Project T10/1826-D

Revision 05 
 22 June 2008

Information technology - SCSI / ATA Translation - 2 (SAT-2)

Summary of Comments on SCSI / ATA Translation Standard

Figure 2 — ATA document structure

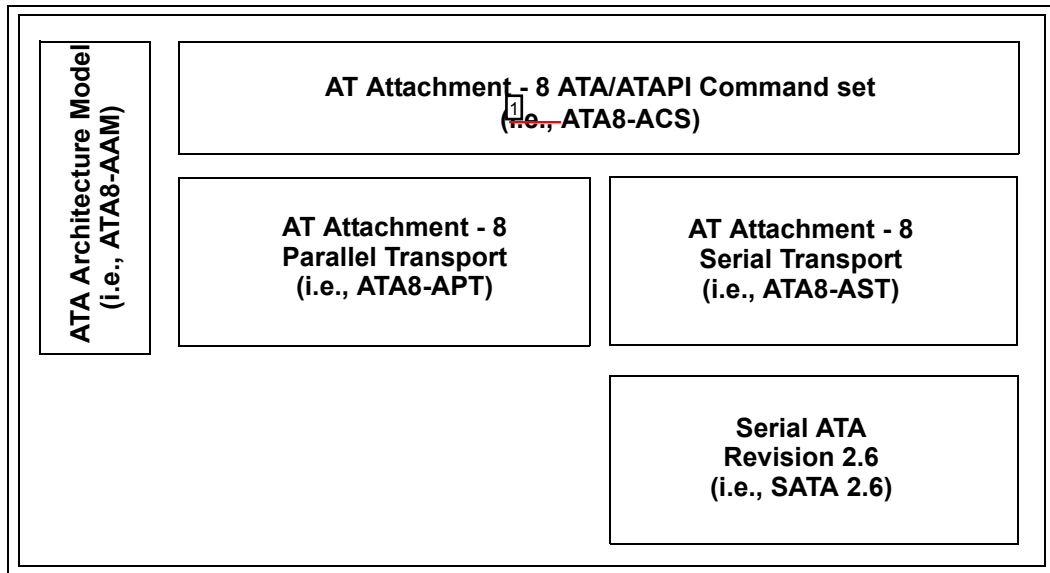
Delete all the "i.e."s from figure 2. That is not used for acronyms in parenthesis - just the acronym is fine, like "(ATA8-ACS)"

Figure 3 — SCSI / ATA Translation document role

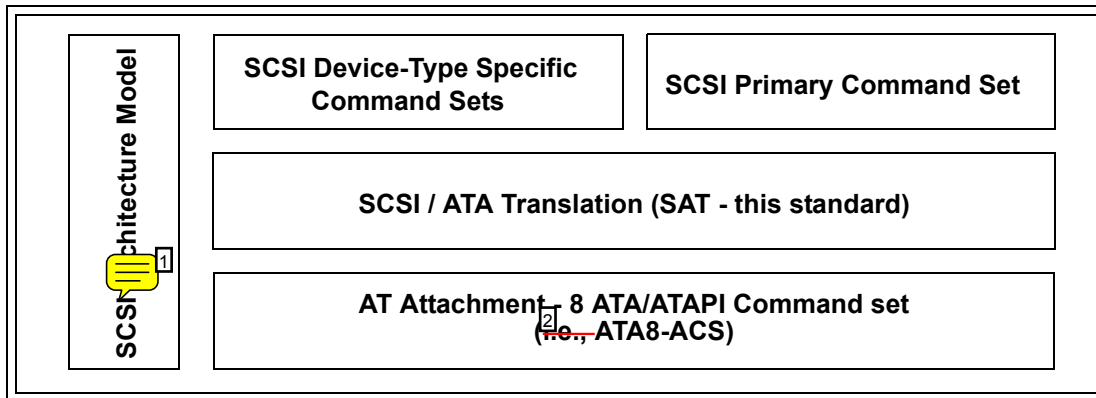
Number: 2 Author: HPQ-RElliott Subject: Cross-Out Date: 9/3/2008 9:42:24 AM
Delete i.e., in figure 3 (see reasoning in comment on figure 2)

Figure 5 — SATL contained within a SCSI to ATA protocol bridge

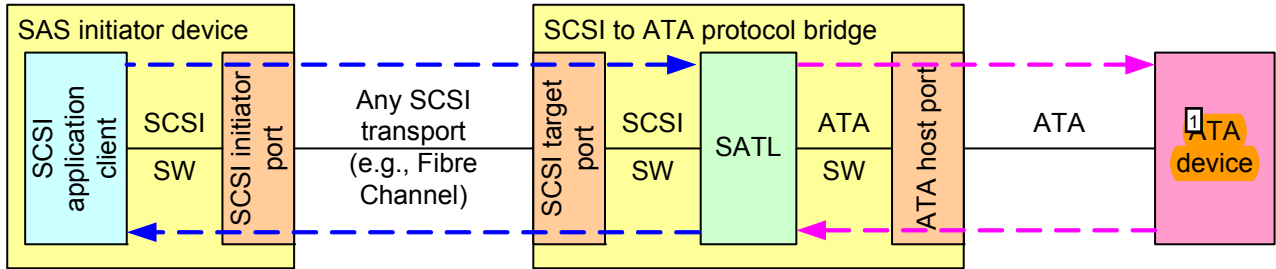
Change these 3 "EXAMPLEs" back into standard paragraphs.

Number: 5 Author: HPQ-RElliott Subject: Highlight Date: 9/3/2008 9:42:24 AM
ATA device
s/b
ATA device or ATAPI device

since "ATA device" is narrowly defined as General feature set only, not a term for all devices defined by the ATA standards

Figure 10 — Translation of Logical Sector Alignment (part 3)

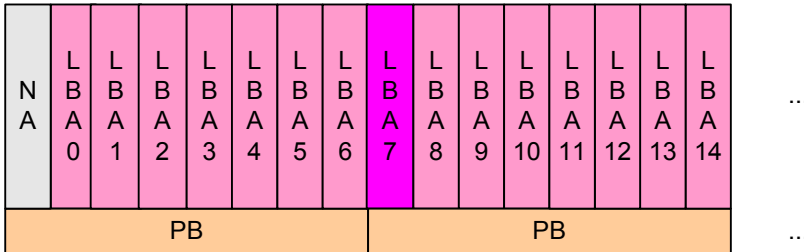
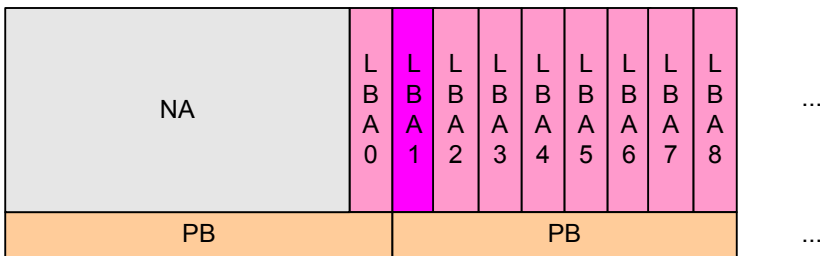
Number: 1 Author: Kevin_Marks Subject: Highlight Date: 8/11/2008 12:51:30 PM
Figure 10 missing reference in text

Figure 8 — REASSIGN BLOCKS command translation

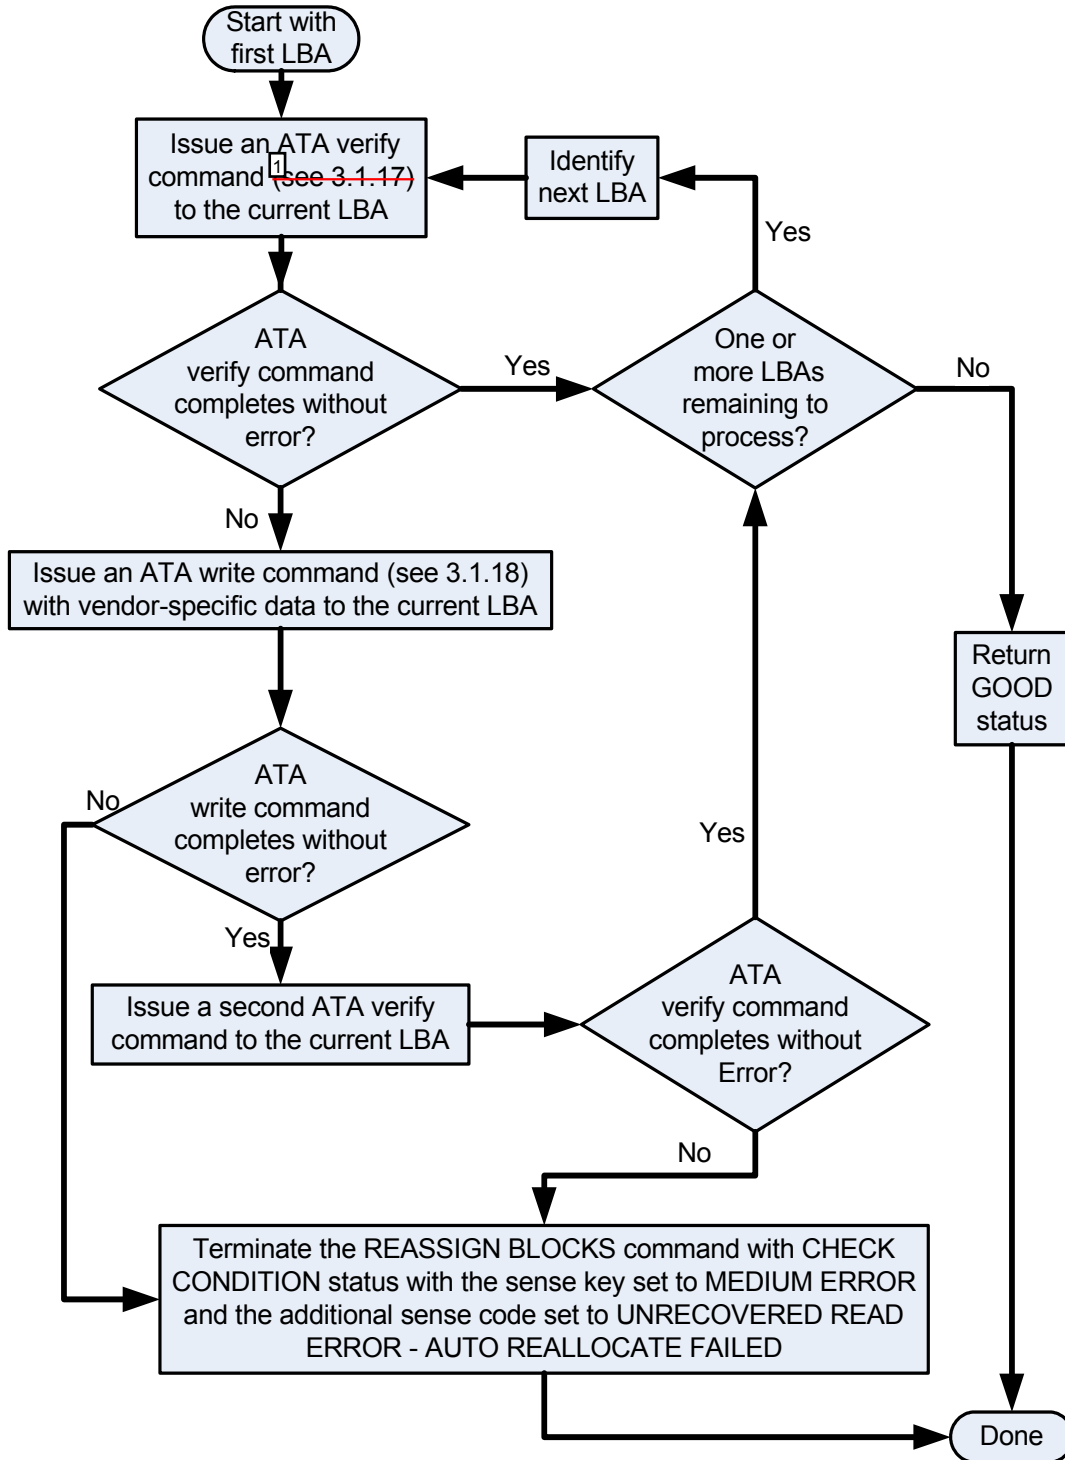
Cannot create active cross references to Frame sections inside Visio figures, so better to leave these out.

Figure 10 — ⁸identification descriptors included by a SATL in a SAS initiator device

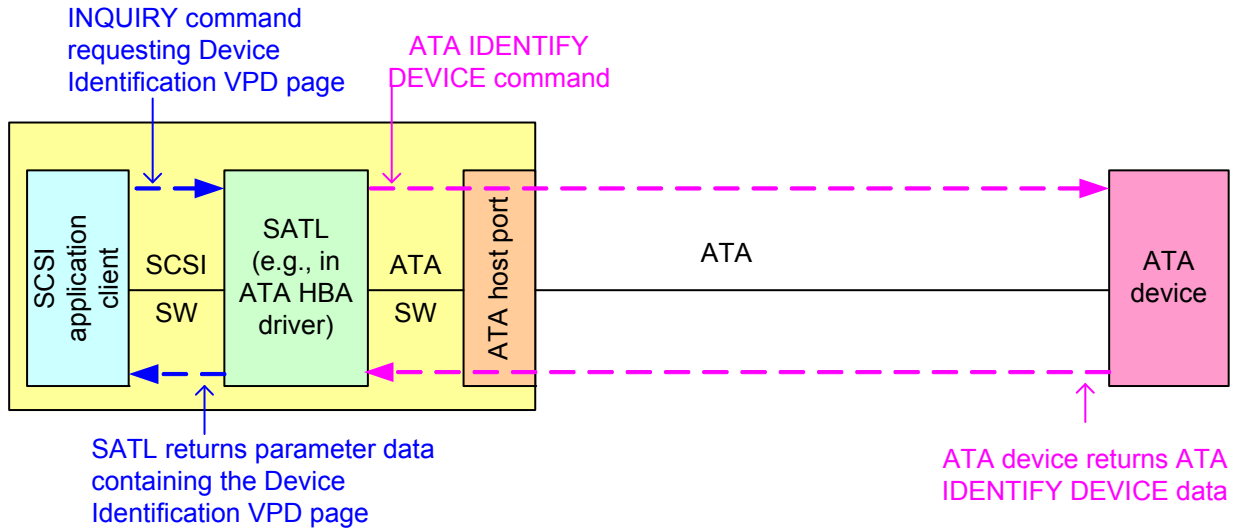
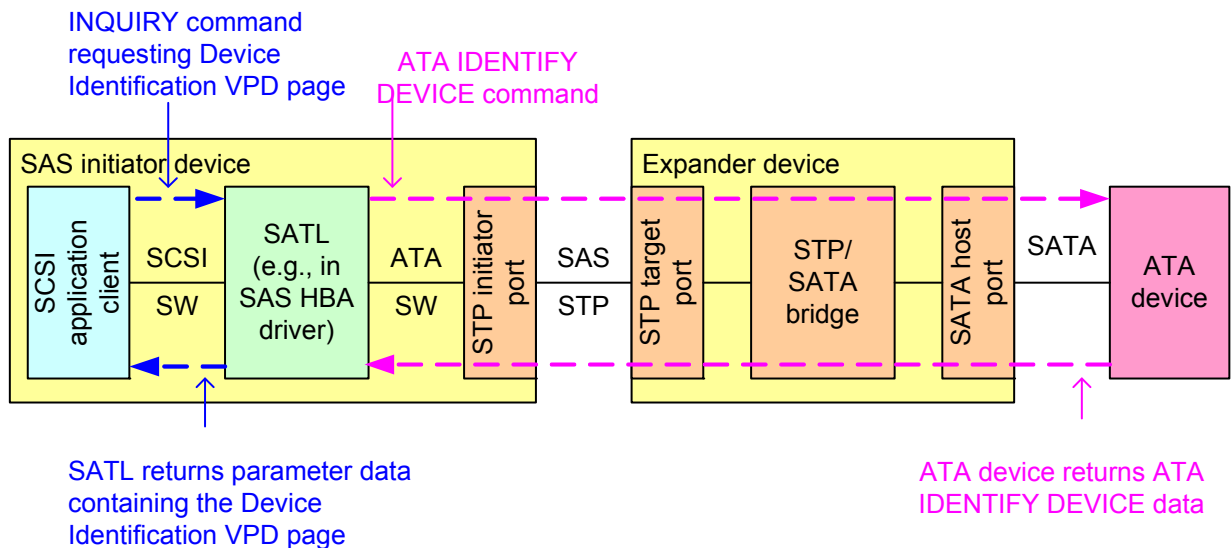
-
- T** Number: 1 Author: Kevin_Marks Subject: Highlight Date: 8/27/2008 11:35:19 AM
identification
s/b
designation
-
- T** Number: 2 Author: Kevin_Marks Subject: Highlight Date: 8/27/2008 11:35:32 AM
identification
s/b
designation
-

Figure 11 — Identification descriptors included by a SATL in a SCSI to ATA protocol bridge

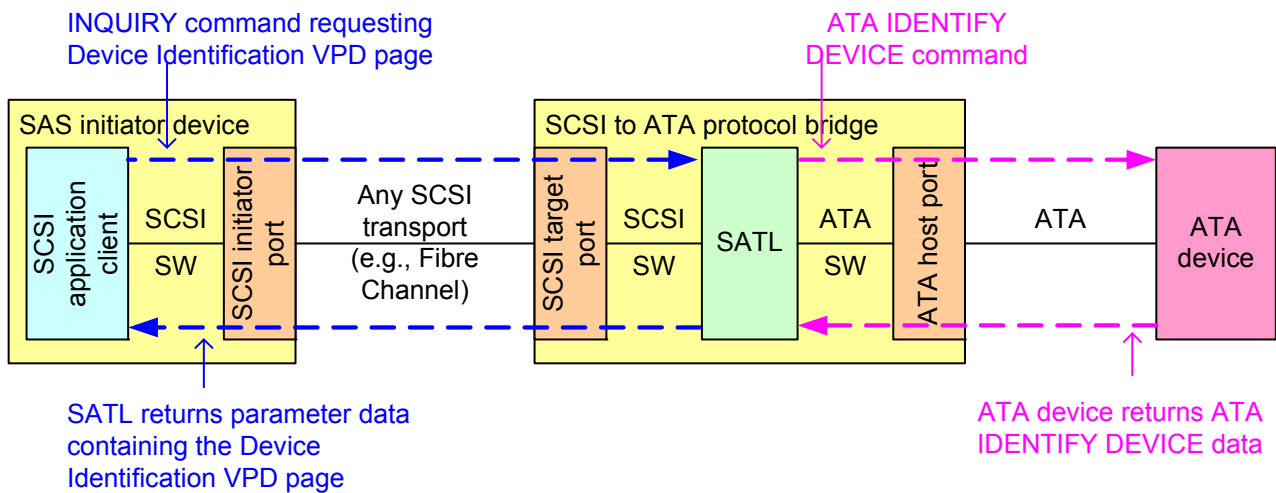
-
- T** Number: 1 Author: HPQ-RElliott Subject: Highlight Date: 9/3/2008 9:42:24 AM
 IDENTIFIER TYPE
 s/b
 DESIGNATOR TYPE
-
- T** Number: 2 Author: Kevin_Marks Subject: Highlight Date: 8/27/2008 11:41:07 AM
 IDENTIFIER
 s/b
 DESIGNATOR
-

Figure 11 — Identification descriptors included by a SATL in a SCSI to ATA protocol bridge

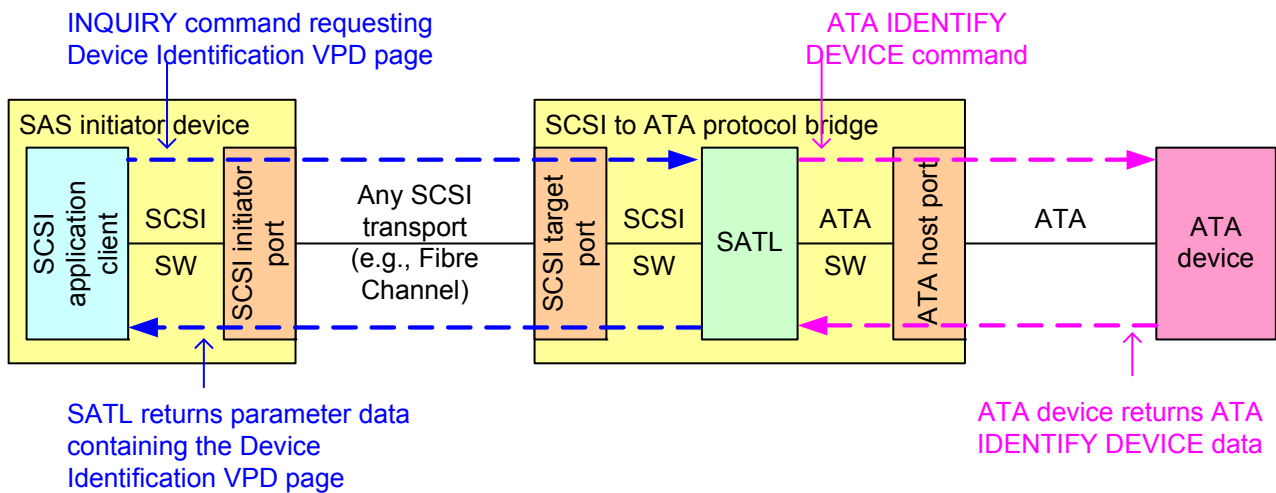
identifier
s/b
designator
